HENSEL PHELPS CONSTRUCTION CO.
☒ REVIEWED ☐ NO EXCEPTIONS TAKEN
☐ REVISE & RESUBMIT ☒ MAKE CORRECTIONS NOTED

CK'D BY AK DATE 7/19/05
SUBMITTAL NO. 00734-10000-4

| M-6009173-010 | | | |

PROJECT: UCI COMPUTER SCIENCE
UNIT 3
EL #1

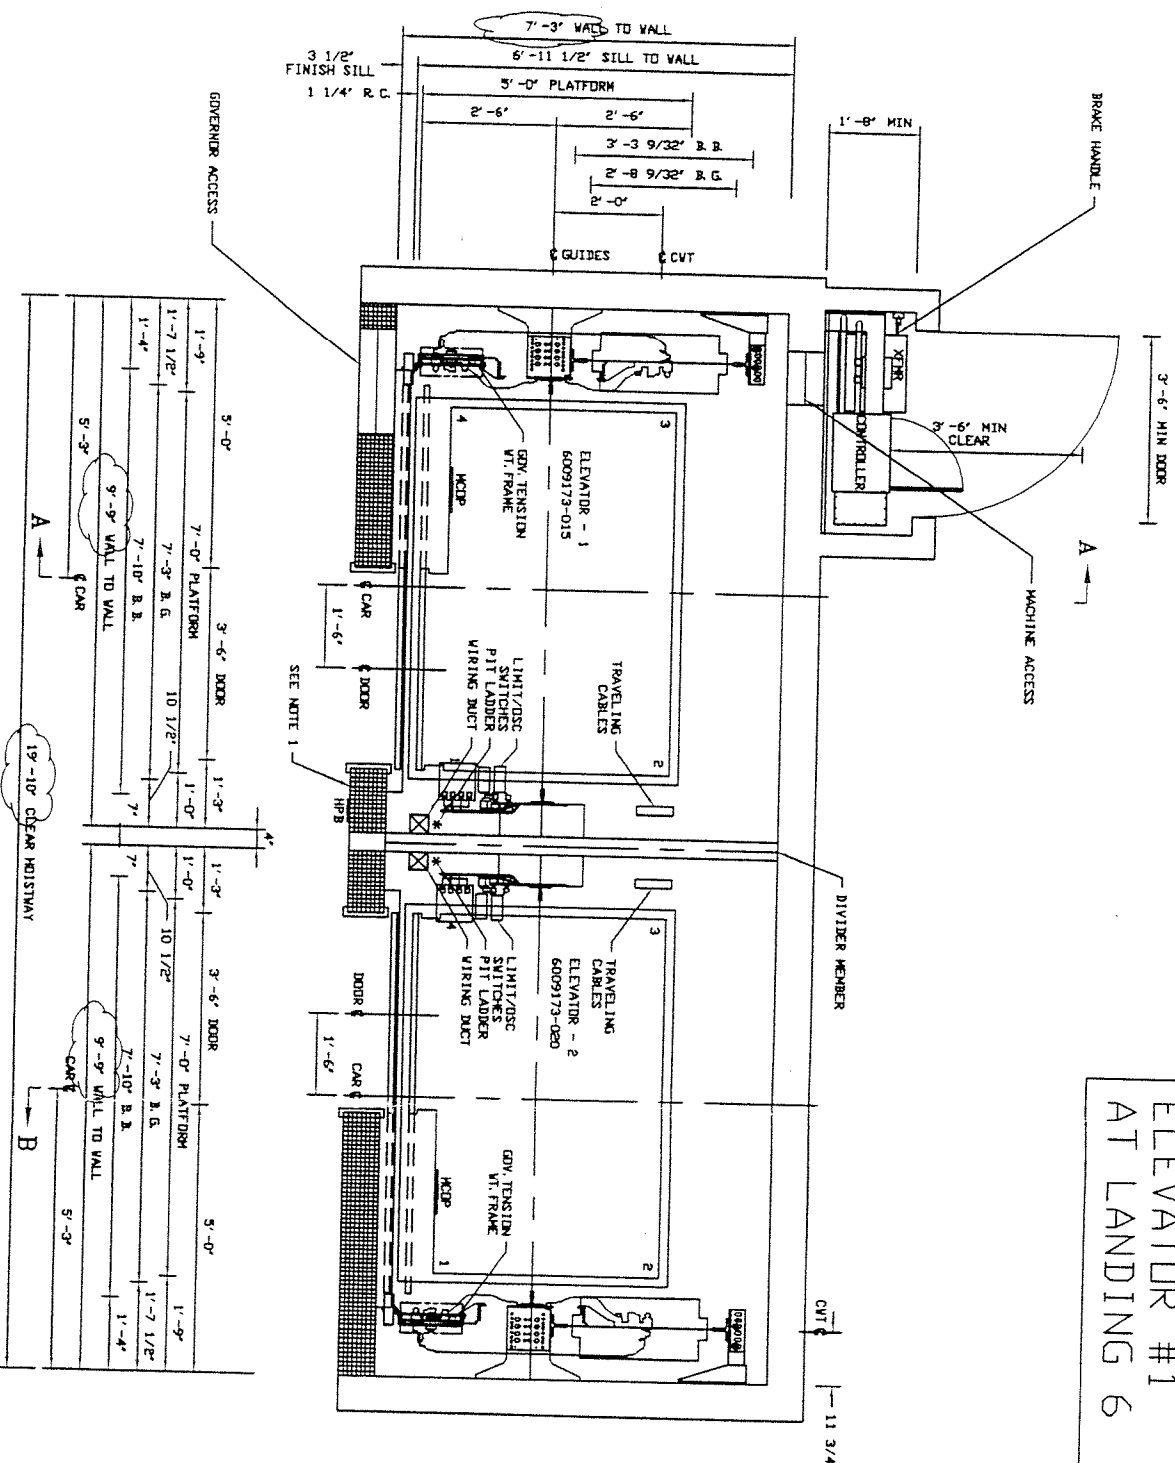
ARCHITECT TO
VERIFY CLOUDED
ITEMS

6009173 ELEVATOR #1

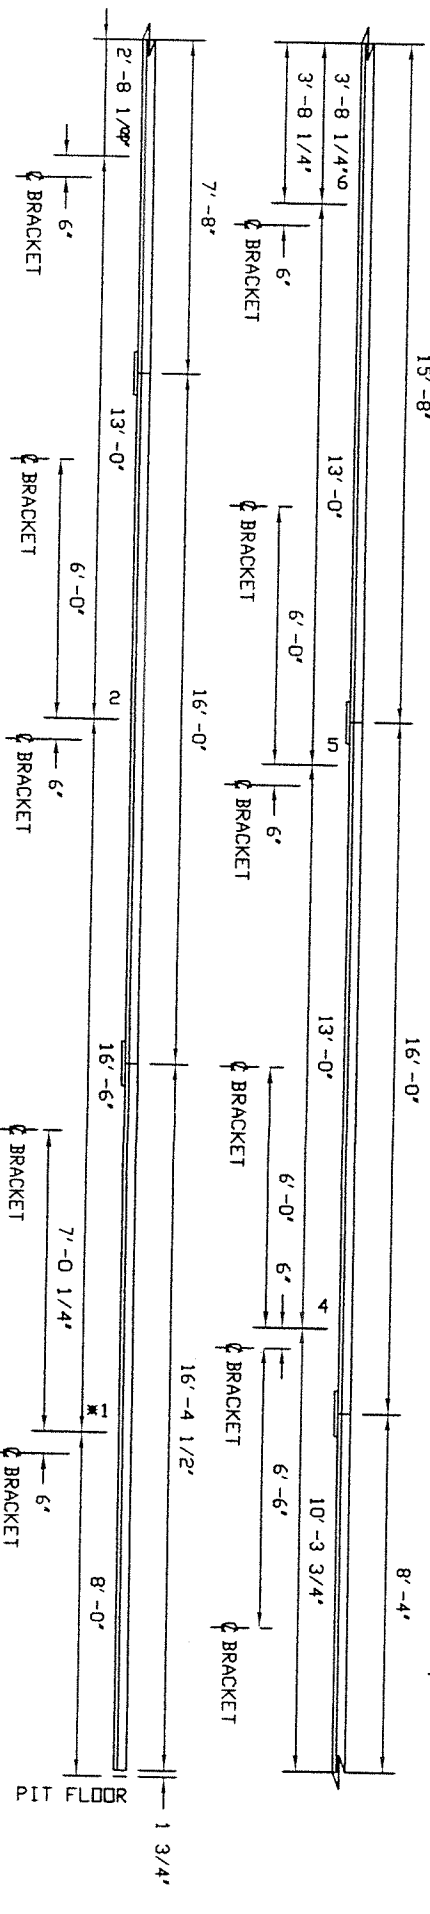
* CWT, TIE BRACKETS DID NOT ATTACH TO BUILDING STRUCTURE.
